# UNITED STATES PATENT AND TRADEMARK OFFICE

APPLICATION NO.	FILING DATE	FIRST NAMED INVENTOR	ATTORNEY DOCKET NO.	CONFIRMATION NO.
10/733,307	12/12/2003	Tsutomu Muraoka	SN-US025011A	7330

**Office Action Summary**

# **ATTACHMENT**

【図8】

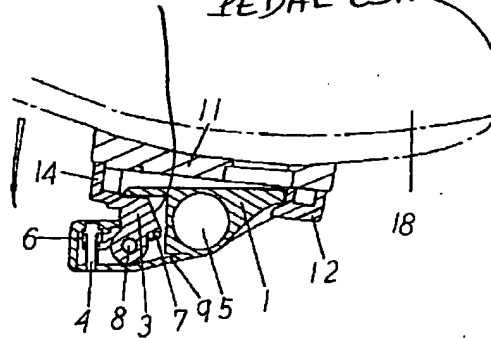
Regarding claim 30, said cleat engagement mechanism 3, 2 includes a front clamping member 2 (Fig. 7) coupled to said front end of said pedal body 1, q and a rear clamping member 3 (Figs. 8 and 9) movably coupled to said rear end of said pedal body 1, q.

Regarding claim 32, said front clamping member 2 includes a rearwardly facing front pedal control surface (Att.), said rear clamping member 3 includes a forwardly facing rear pedal control surface (Att.).

【図10】

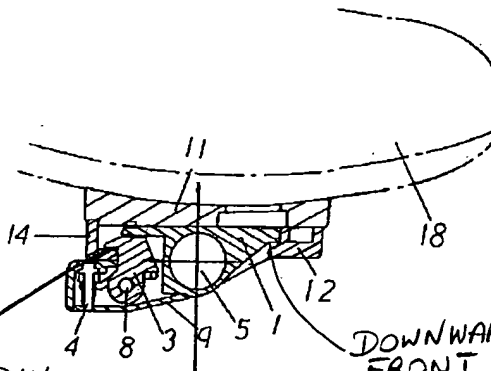
Regarding claim 31, said front clamping member 2 includes a downwardly facing front cleat engagement surface (Att.) disposed in a first plane (Att.), and said rear clamping member 3 includes a downwardly facing rear cleat engagement surface (Att.) disposed in a second plane (Att.) that is offset from said first plane (Att.) of said front cleat engagement surface 2 as best seen in Figs. 2 and 10.

Regarding claim 33, said front and rear cleat engagement surfaces (Att.) are *substantially* parallel as seen in, e.g., Figs. 2 and 10.

Date's first plane (Fig. 10 of Att.) of the front cleat engagement surface 2 is farther to the center rotation axis (Att.) than the second plane (Att.) of the rear cleat engagement surface (Att.) as measured in a direction perpendicular to the first and second planes (Att.).
